# CITY OF ALBUQUERQUE

**RE: 10000 Central Ave SW  
Conceptual Grading & Drainage Plan  
Engineer's Stamp Date: 02/19/2025  
Hydrology File: L09D042**

Based upon the information provided in your submittal received 02/20/2025, the Conceptual Grading & Drainage Plan is preliminary approved for action by the Development Facilitation Team (DFT) or Development Hearing Officer (DHO) on Site Plan for Building Permit.

## 2615 CG-101 CONCEPTUAL - CG-101 CONCEPTUAL GRADING +

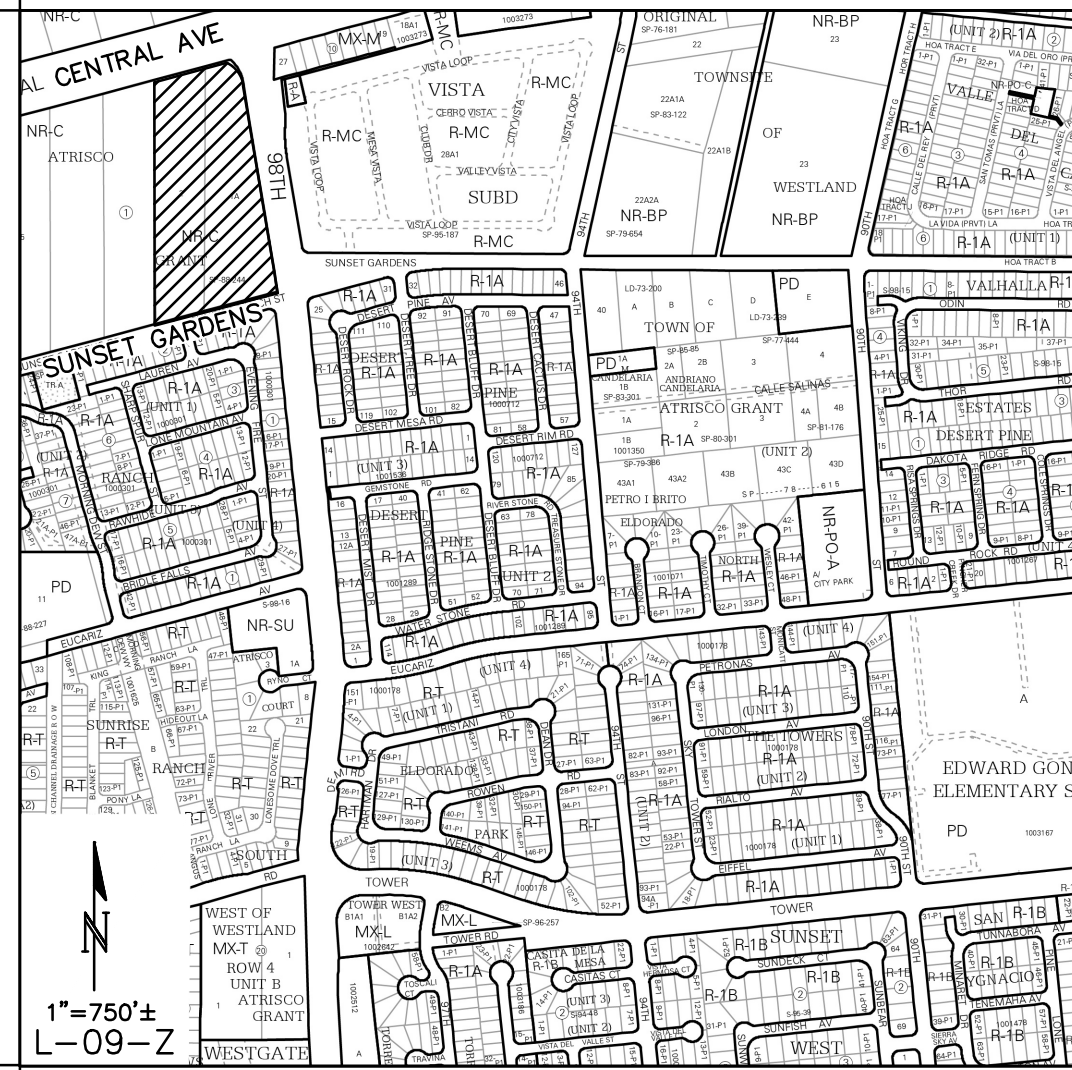
1. Please submit the Grading & Drainage Plan to Hydrology for review and approval through the ABQ-PLAN portal.
